Addendum

No. ELEVEN Date: 9/12/08

Project: ADDITIONS AND RENOVATIONS TO
DALRAIDA ELEMENTARY SCHOOL
FOR
THE MONTGOMERY COUNTY BOARD OF EDUCATION
MONTGOMERY, ALABAMA

Project No. 07-138

2
A-7.5

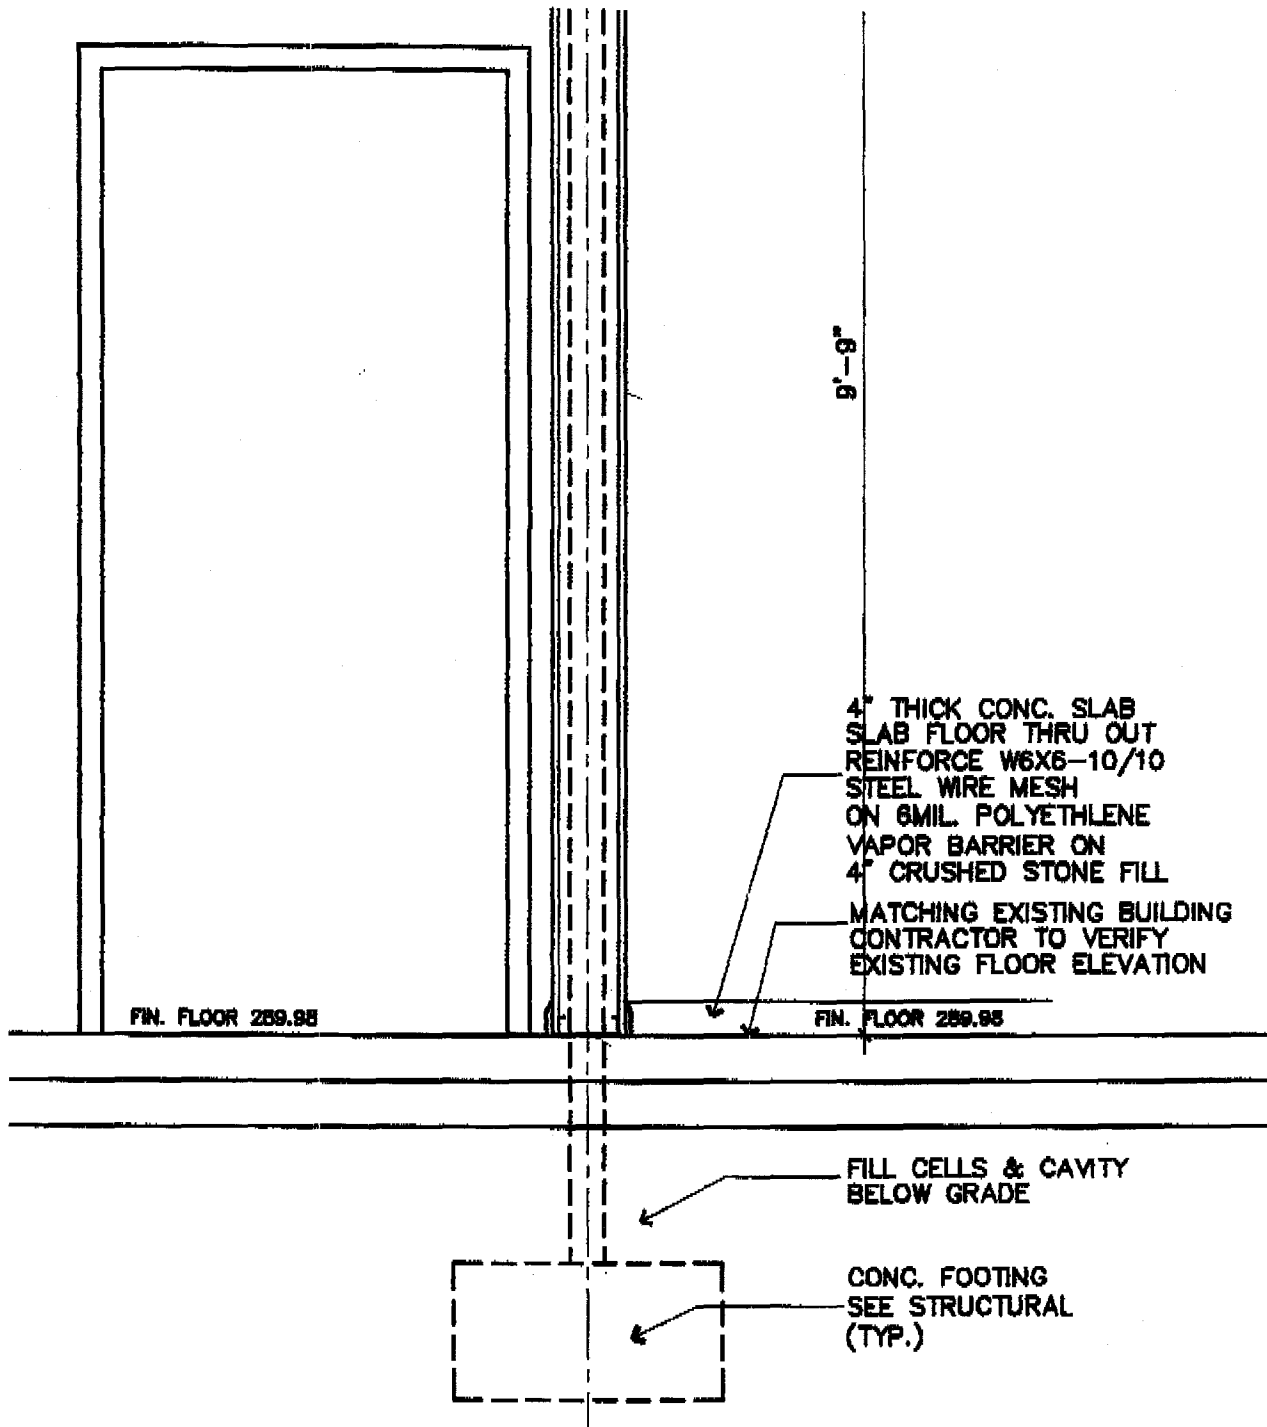
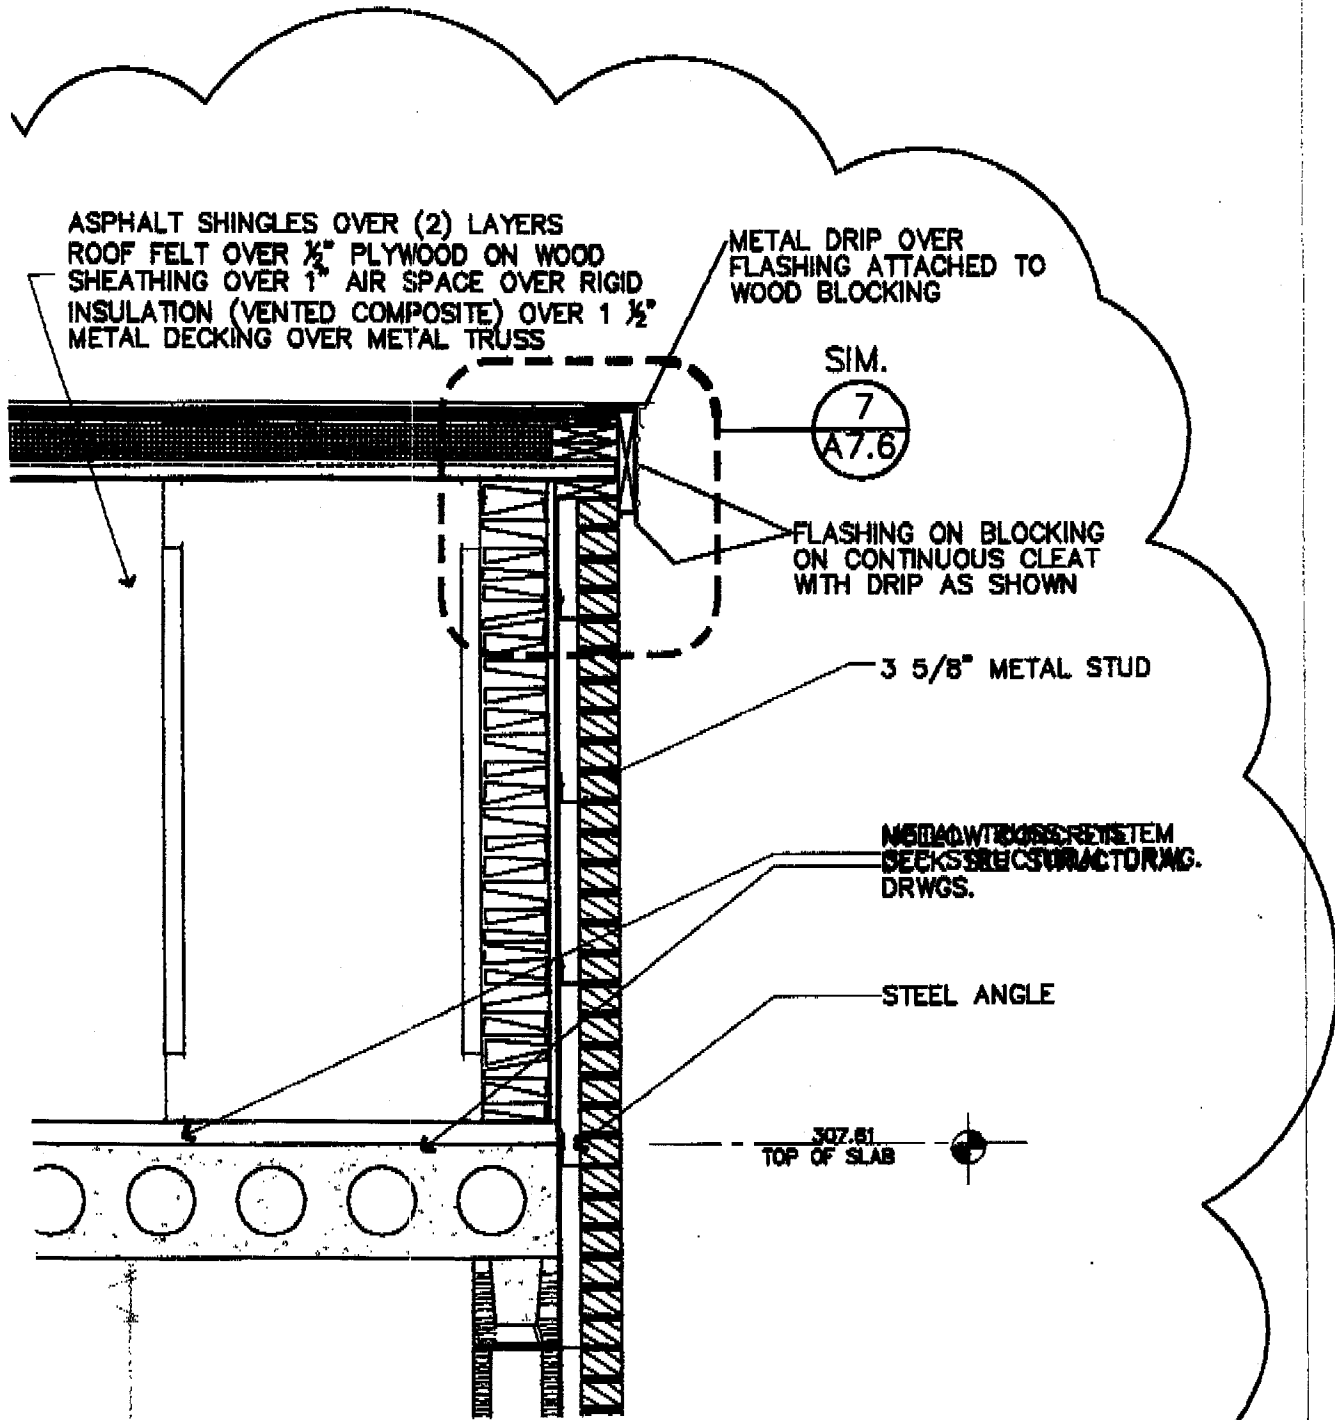
- A. **Clarification:** Aluminum frames for FRP Doors shall be by the Storefront Manufacture.
- B. Refer to **Sheet A-5.1**, Door Schedule, change as follows:
- Door 221 shall be the same as Door 120.
- C. **Plumbing Addendum:** In lieu of the one (1) 1,500 gallon grease trap shown on the drawings, provide two (2) 1,500 gallon grease traps in series with sampling well on discharge side of grease traps. Grease traps and sampling well shall conform to the City of Montgomery Water Works and Sanitary Sewer Board requirements.
- D. See attached **Supplemental Drawings – Item #75 and #76** for changes to Section 2/A-7.5.
- E. See attached **Supplemental Drawings – Item #77 and #78** for changes to Section 3/A-7.5.
- F. See attached **Supplemental Drawings – Item #79 and #80** for changes to Section 4/A-7.5.

5
A-7.5

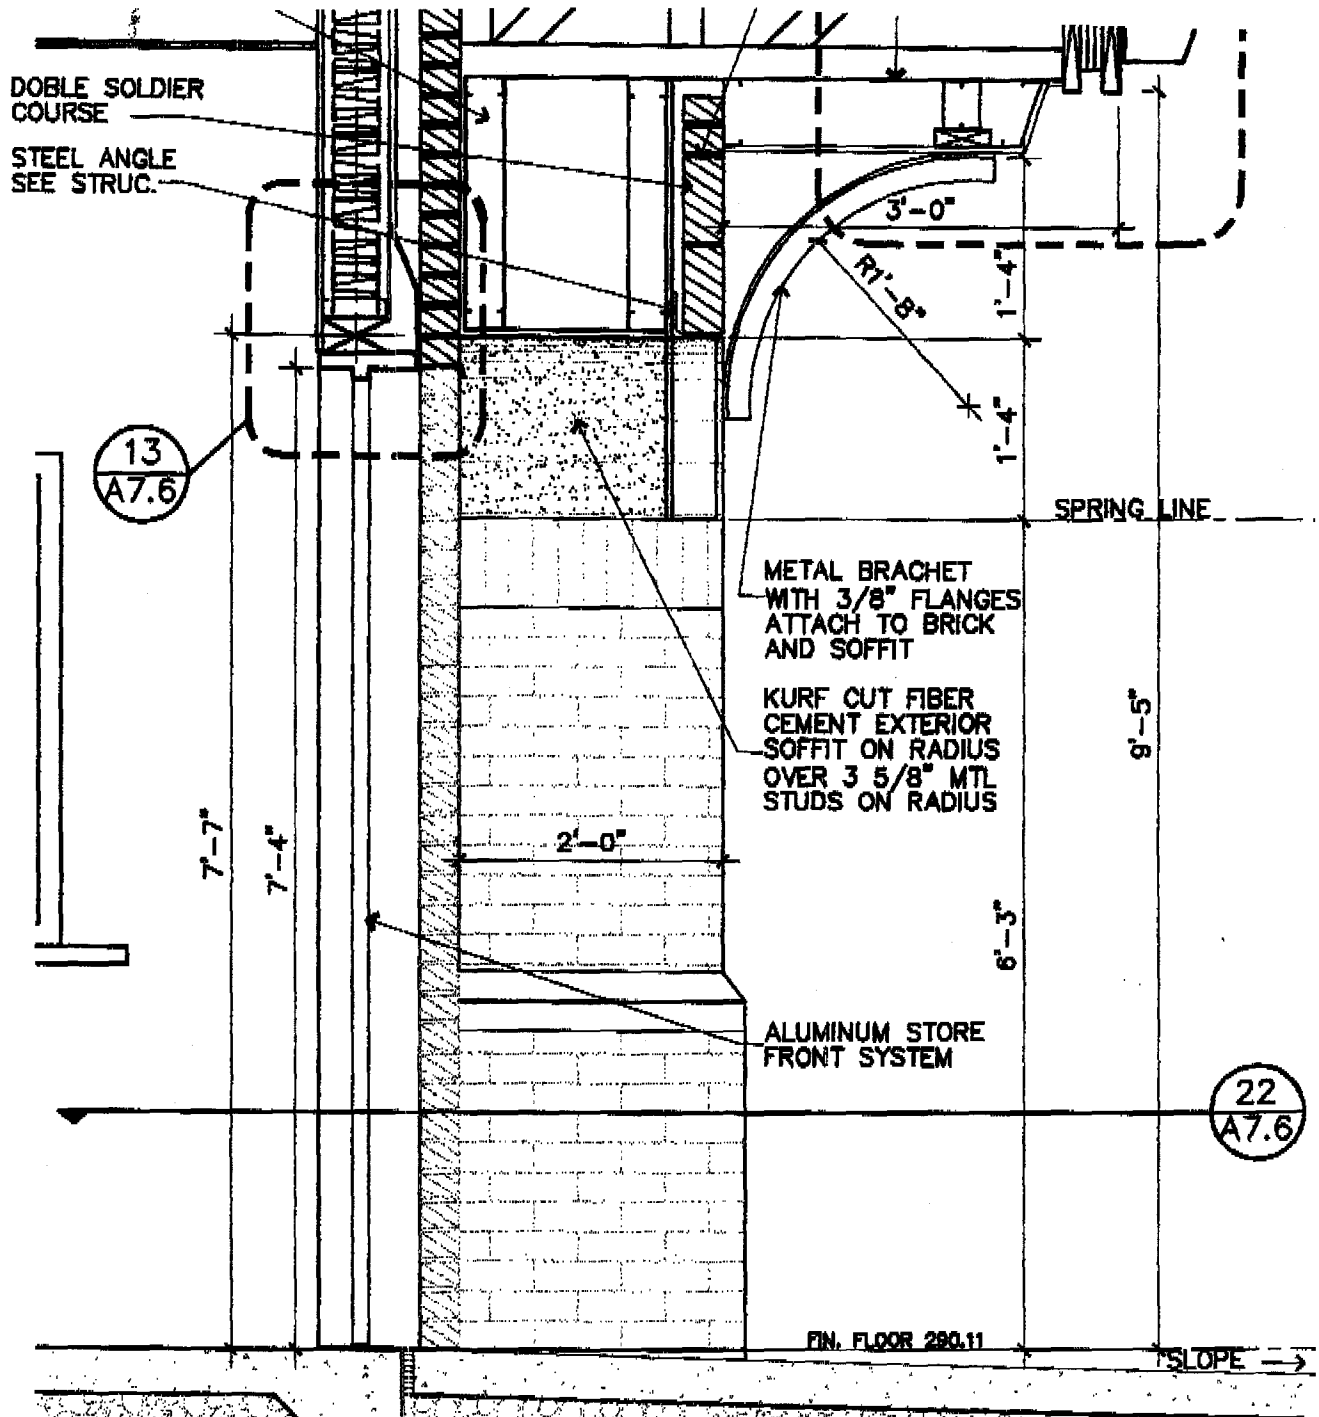
- G. See attached **Supplemental Drawings -- Item #81 and #82** for changes to Section 5/A-7.5.
